Information Sheet

Bayou Lite Proposal for Kirkwood Lift Station Rerouting

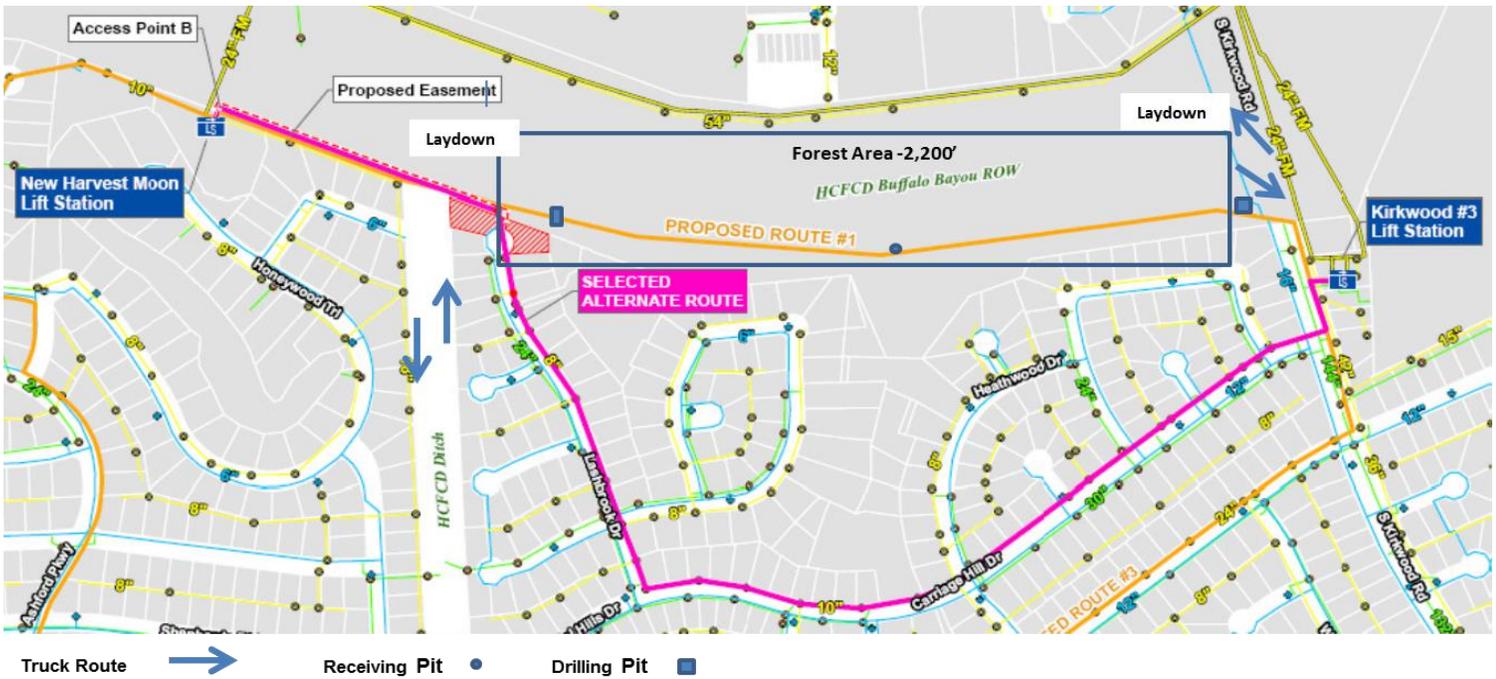
Drill pits would be located on at the edge of the forest just west of Kirkwood rd. and 200 to 400 ft. east of Lashbrook (depending on whether manholes are at 800 or 1,000 ft. intervals) and drill to the center of the forested area. The receiving pit would be accessed from Lashbrook. The Kirkwood/receiving pit pipe run would span the major gully on the route and not require any storm water feature or access road. The access road would be limited to 10 to 15 ft. with turn-arounds and wide-outs as required. The proposed access road is comparable to access roads on HCFCB ditch, Terry Hersey Park asphalt path, and access road in Harvest Moon L.S. Replacement one-for-one of any trees removed in the construction activity.

- Avoids the major ravine
- Road length cut in half, width reduced by half
- Avoids the biggest gully
- Easy (non-neighborhood) truck access and egress
- Natural laydown areas close to construction area(outside of neighborhood)
- Benefits:
 - Significantly less impact to Bayou
 - Reduced costs for Bayou route

- Costs for HCFCB restoration seem inconsistent for Option 1-Bayou and Option 2- Carriage Hill given that there is 1080 ft of common route where the option 2 costs should apply to Option 1 as well.

- Please detail any residual storm water feature after adjusting for the major gully.
